工程指示 / 要求簡箋(E.I.)

工程指示編號：EI / 4430 / 22

工程名稱：將軍澳日出康城 11

工程項目：幕牆 鋁料鋁碼模圖(2 個) (X86255, X86256)

DRAWING NO.  
X86255

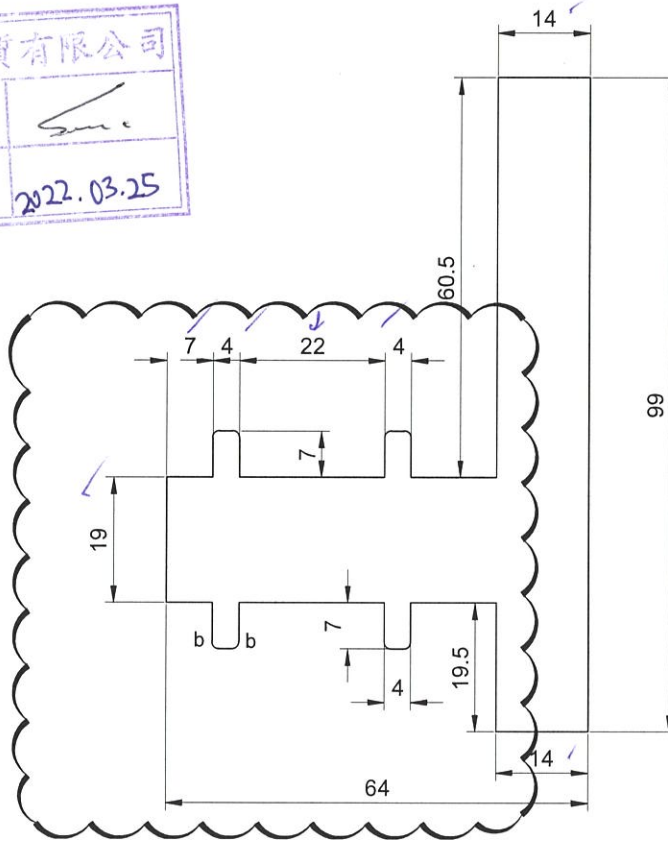
**B 版：掛勾碼按結構工程師建議 增加 3mm movement 18mm 改成 22mm (X86255, X86256)**
